Our Case Number: ABP-319866-24

Re: Proposed development known as North Irish Sea Array ("NISA") Offshore Wind Farm
Located off the coast of Counties Dublin, Meath and Louth (www.northirishsearraysid.ie)

Re: Planning Application by North Irish Sea Array Windfarm Ltd (NISA)

ABP Case Ref OA29N.319866

Appendix 4

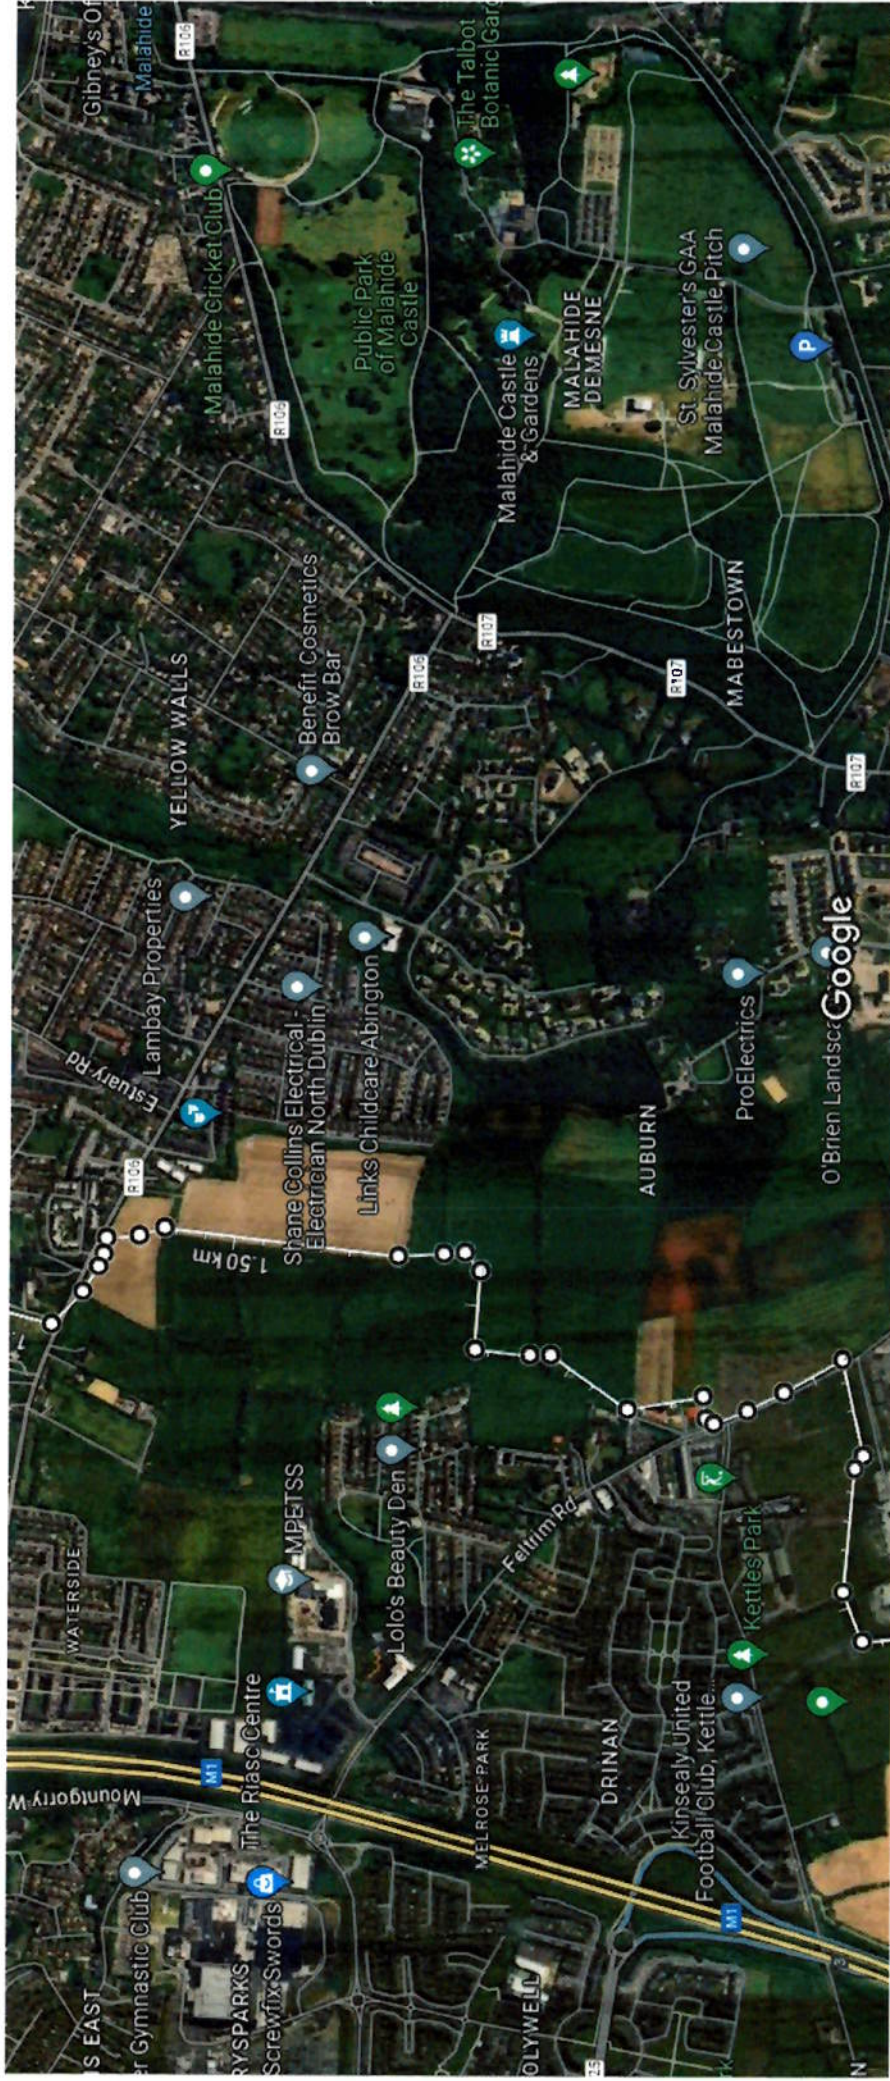
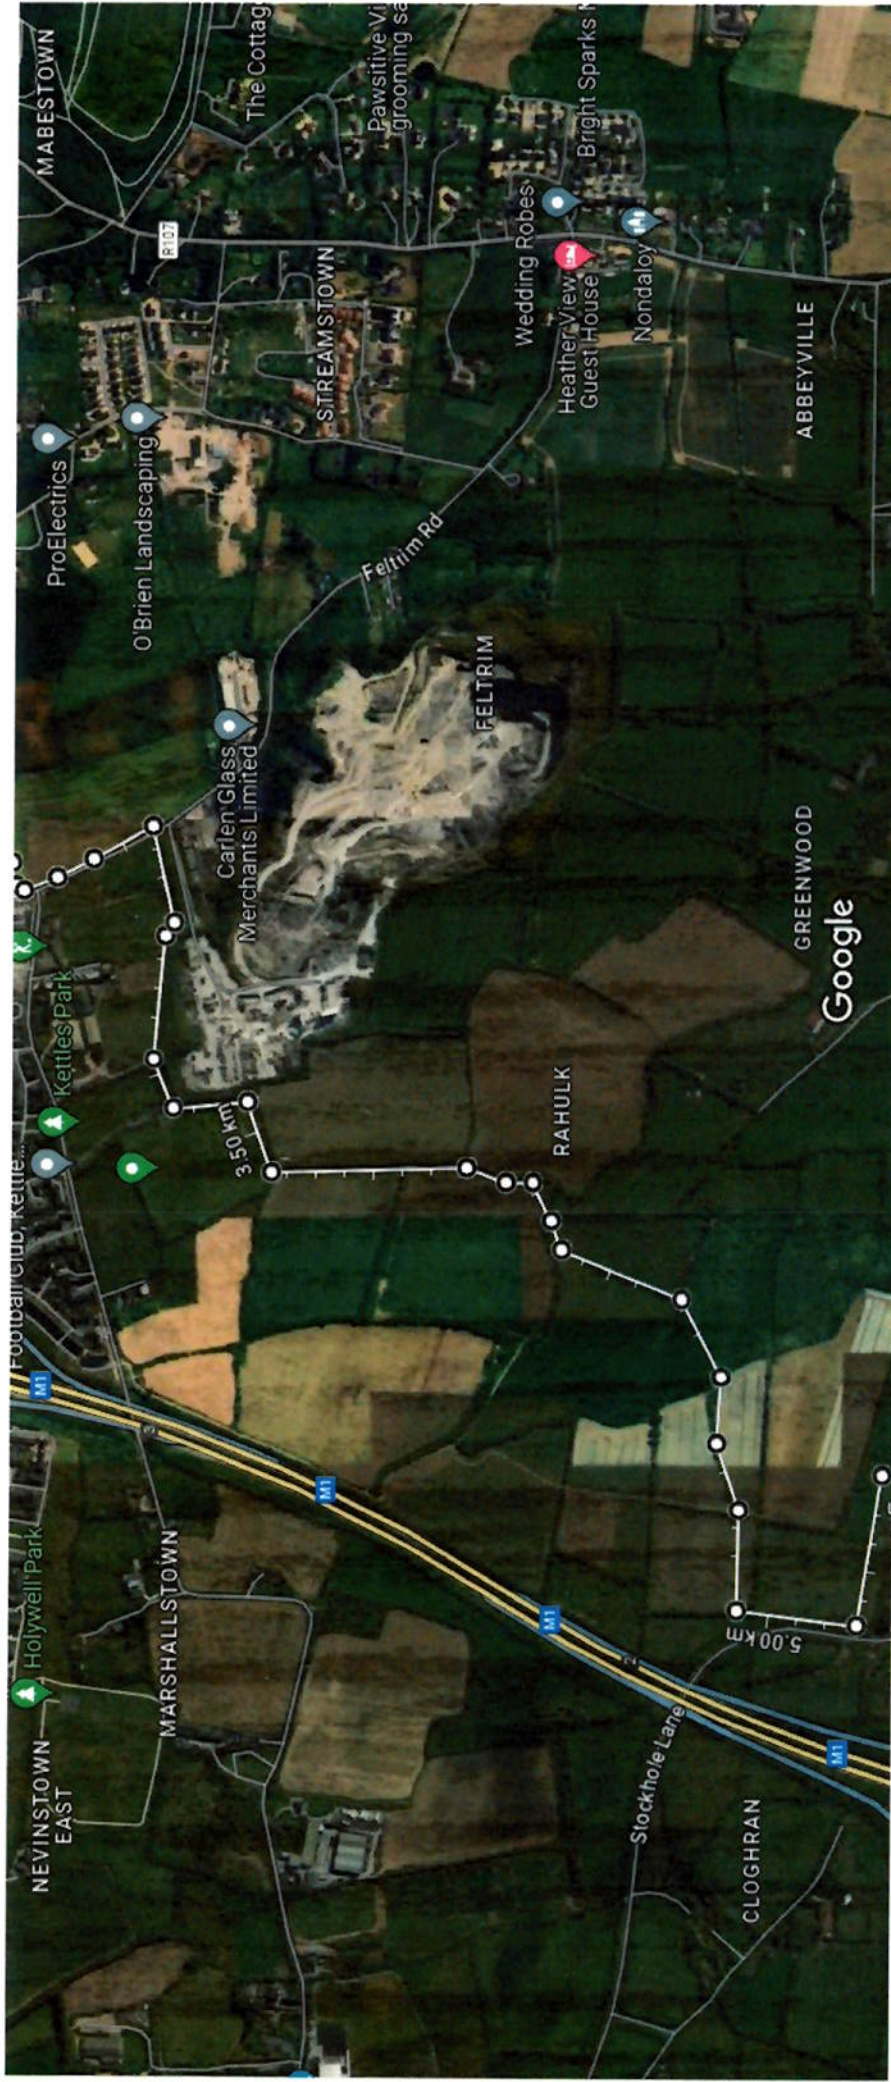
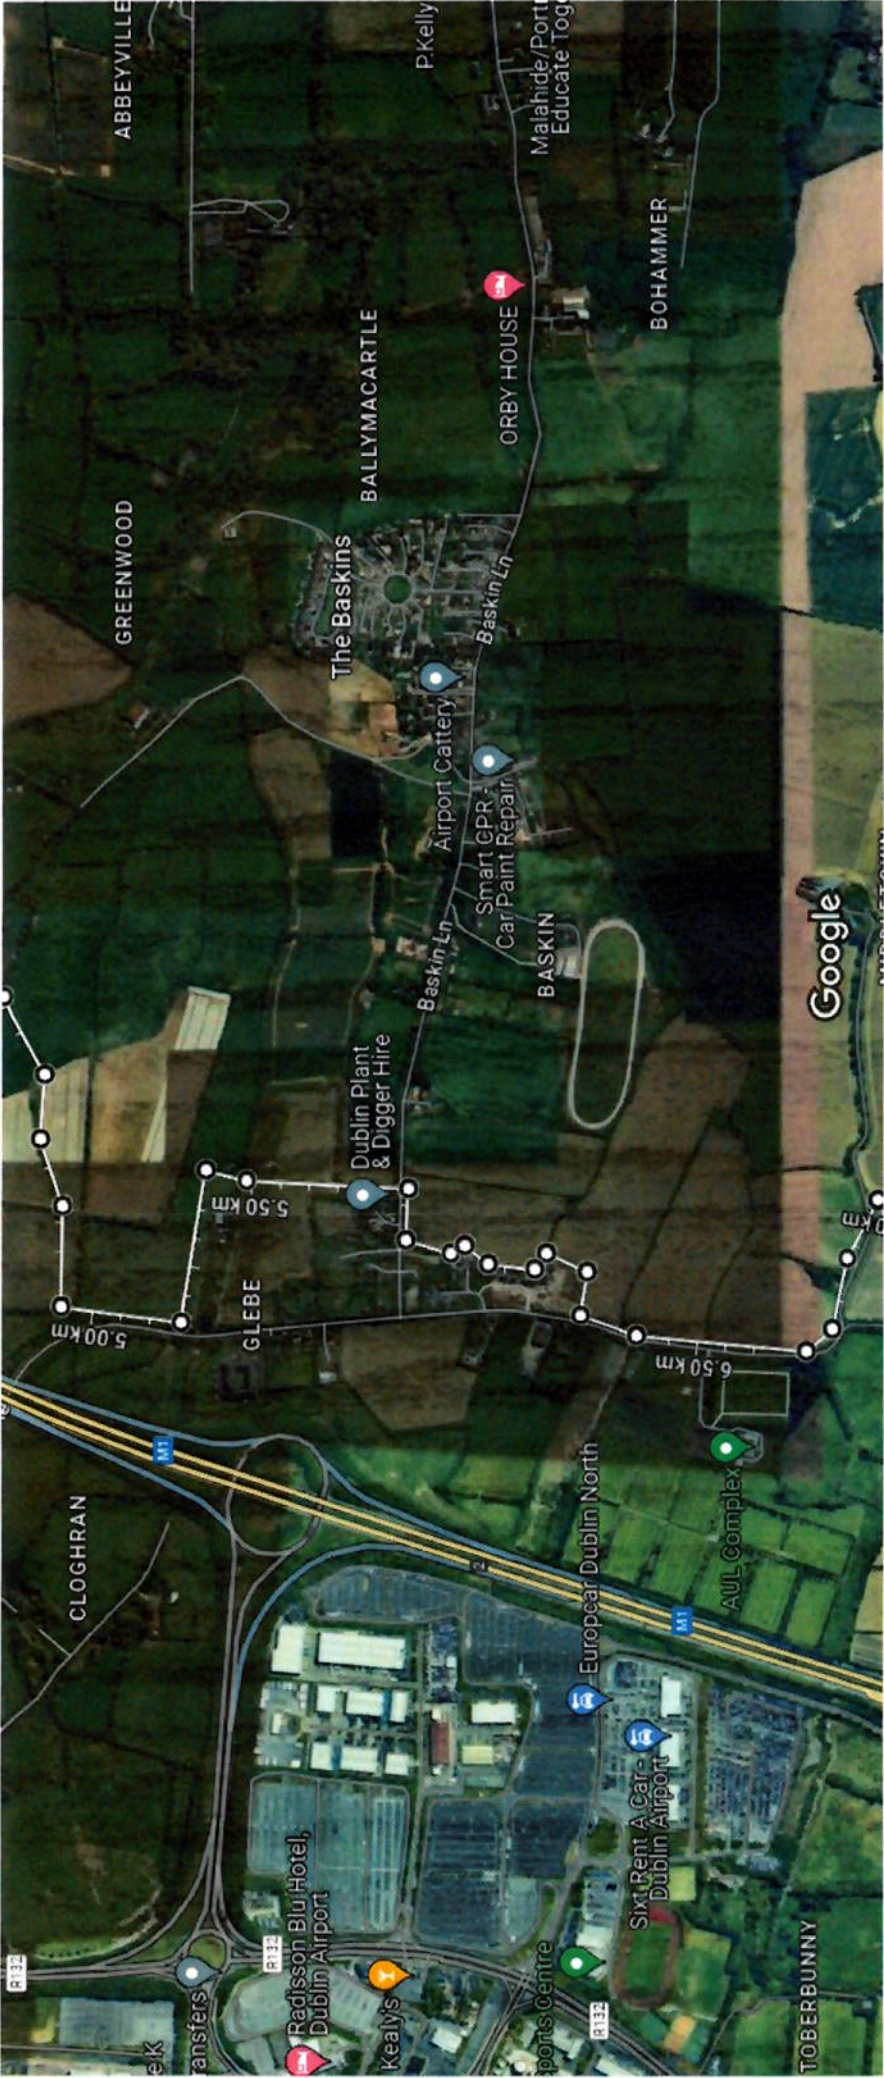
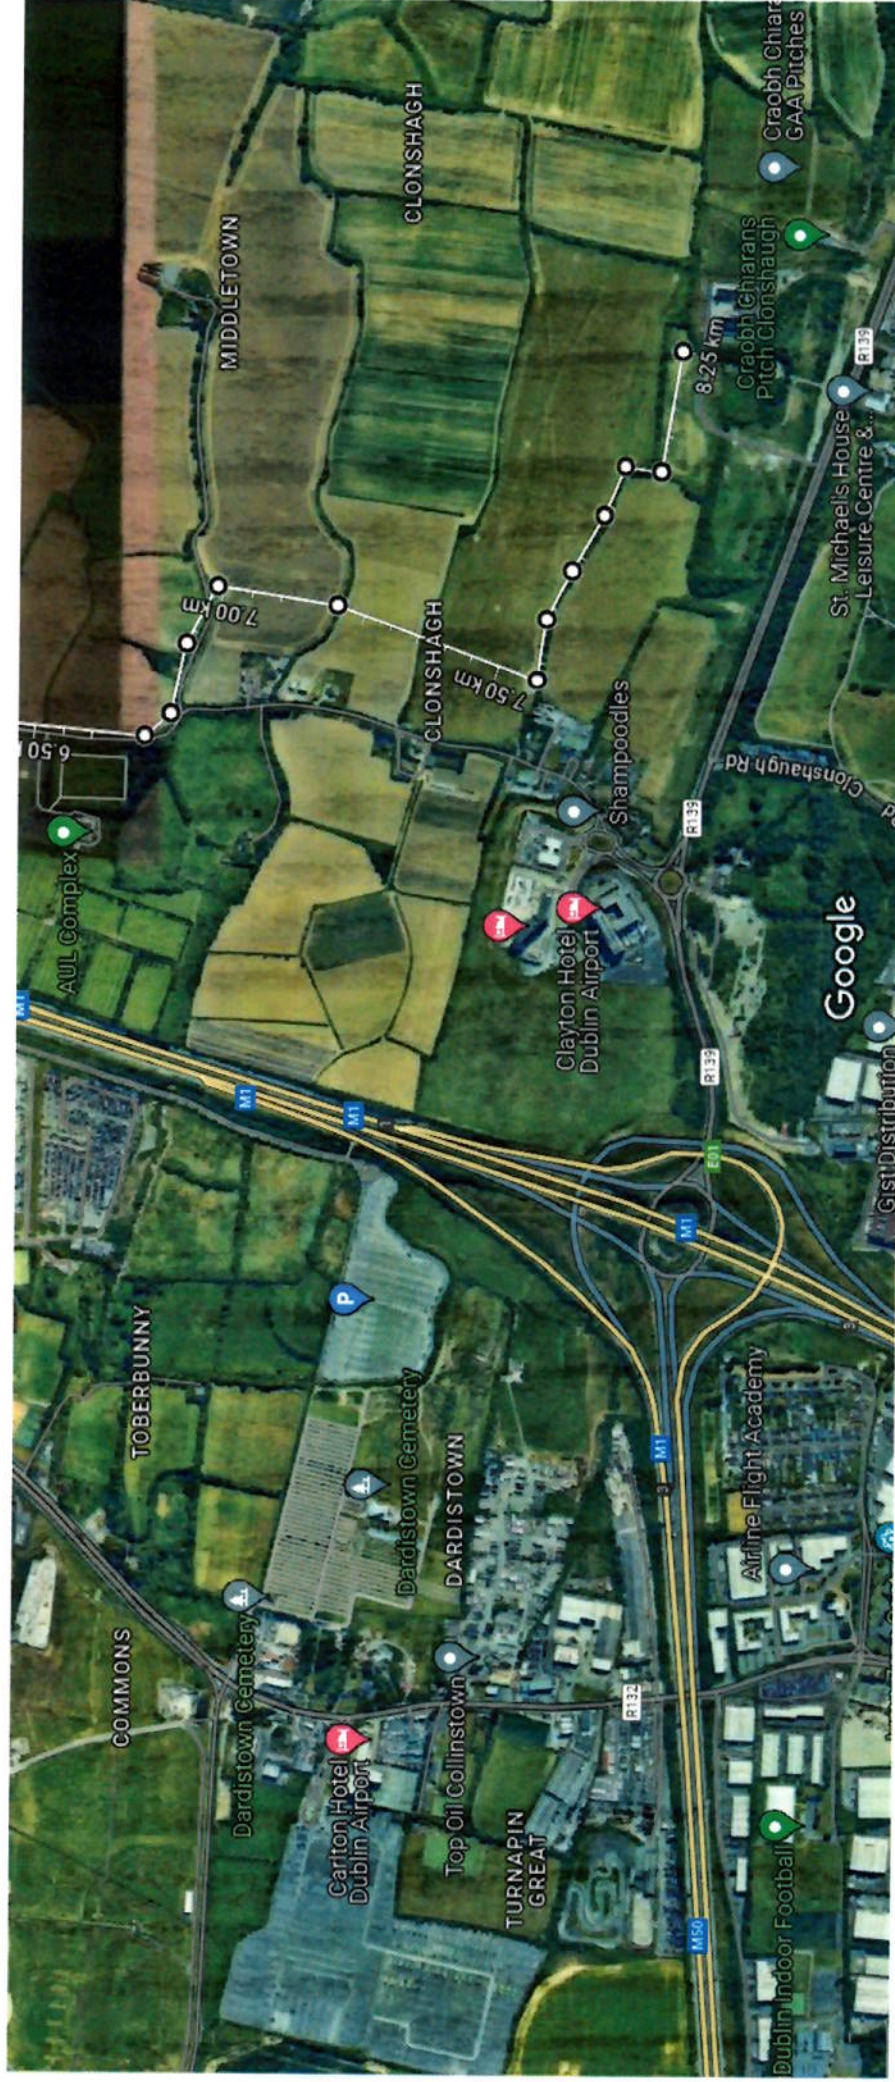
MCF considers that a perfectly feasible cross country route alignment can be developed from Malahide Rugby Club grounds, on Estuary Rd Malahide to Stockhole Lane, Cloghran, where EirGrid's proposed East Meath-North Dublin 400kV cable crosses under the M1.

From there both the proposed NISA and EirGrid cables could be routed along the off-road alignment, proposed in EirGrid's application, to Belcamp 220kV substation i.e. from chainage 34450 to 37550, a distance of 3.1km. The potential for this section of the EirGrid alignment to be used as a shared cable corridor was referenced in the documentation submitted by EirGrid with their application.

Appendix 4 contains Google Satellite maps showing MCF's suggested alignment, it also contains folio mapping, with the route sections through different landholdings outlined in colour and it includes a schedule of landowners along the proposed route to Stockhole Lane. Landowners controlling over 90% of the proposed alternative alignment have been consulted on MCF's proposal. It also contains the route maps submitted by EirGrid for the off-road cable route between chainage 34450 and 37550.

In view of the above arguments MCF requests that if ABP grants Planning Approval for this application it include a condition that *All components of the proposed development between Malahide Rugby Club, Estuary Rd. Malahide and Belcamp 220kV substation shall not be developed in accordance with the submitted application drawings and details.*

Image 1.6: Section 12 Full Road Closure Diversion Route

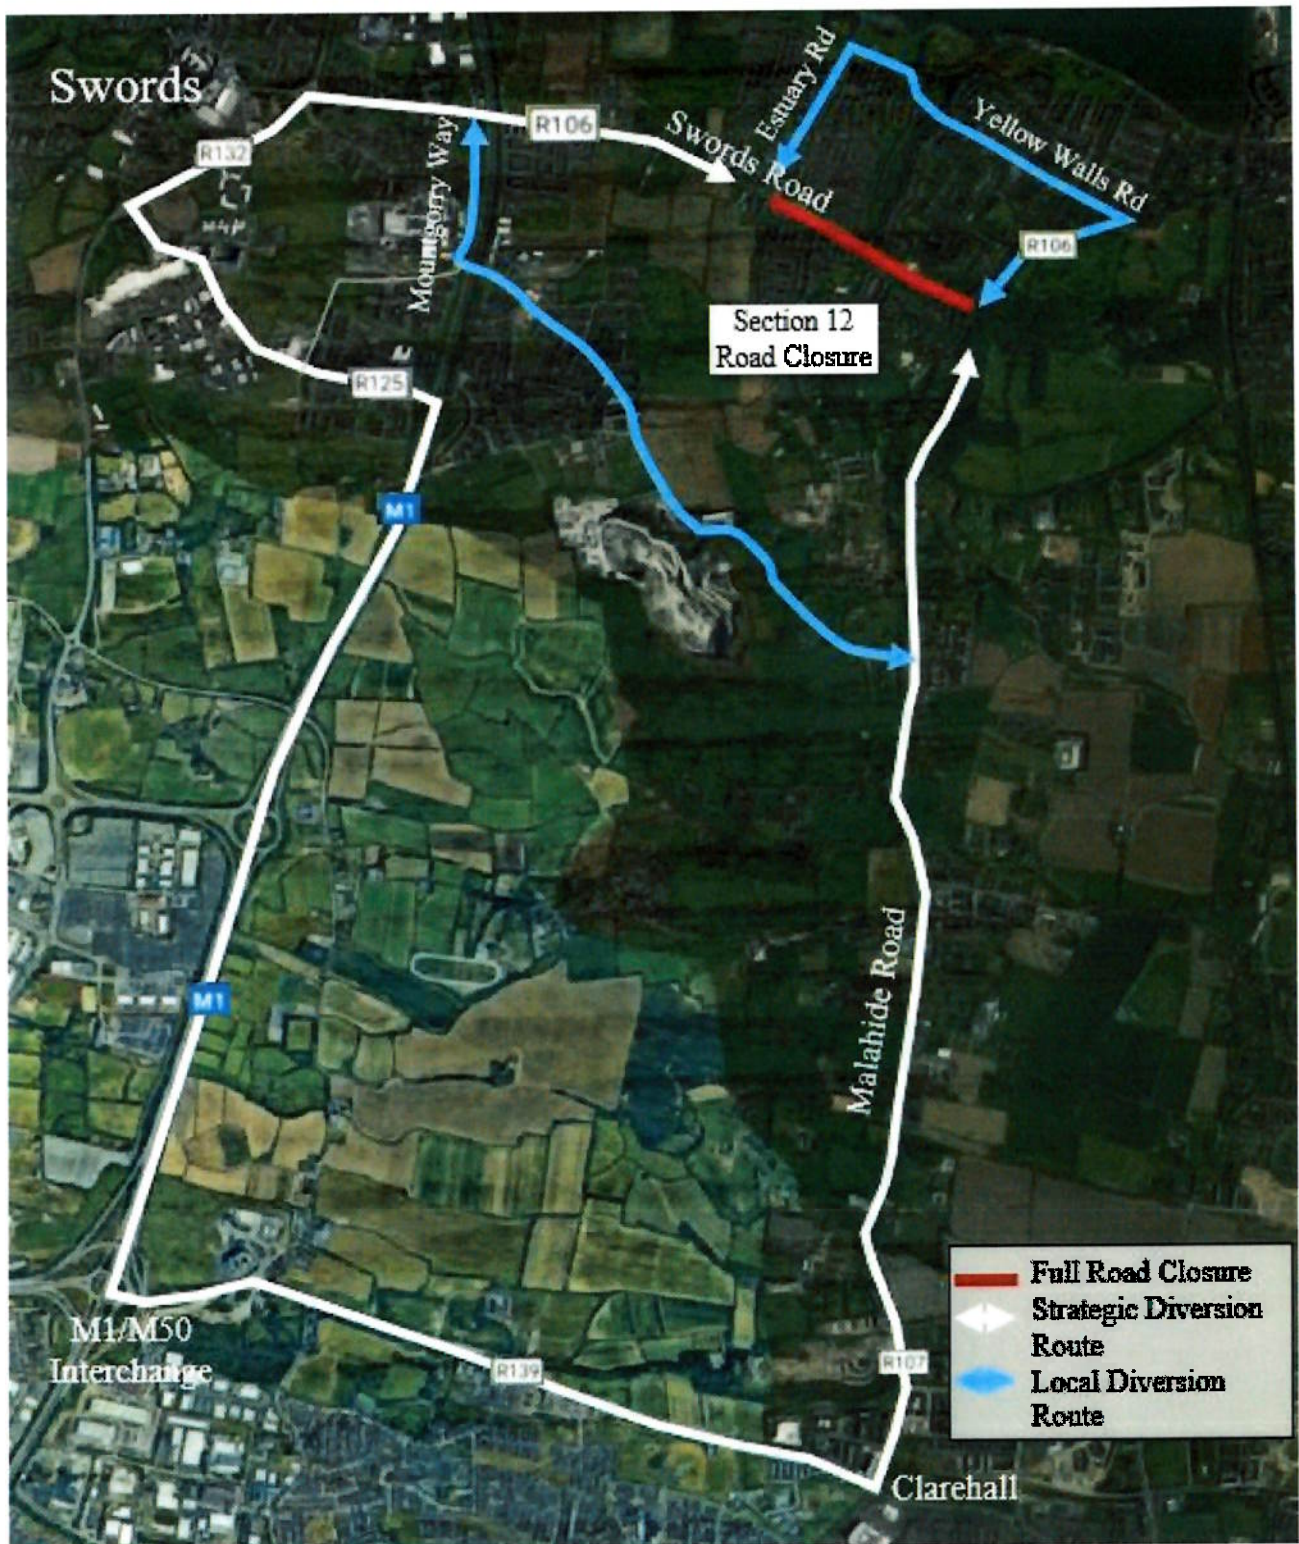
The applicant proposes that the considerable volume of traffic between Malahide and Swords, currently using the Swords Rd. could be diverted onto Yellow Walls Rd, when the Swords Rd. is closed, Image 1.6. This is utterly unrealistic as Yellow Walls Rd. is already totally substandard, particularly on the section around Barrack Bridge. Improving the alignment and safety on this road section has been on Fingal County Council's agenda for decades.
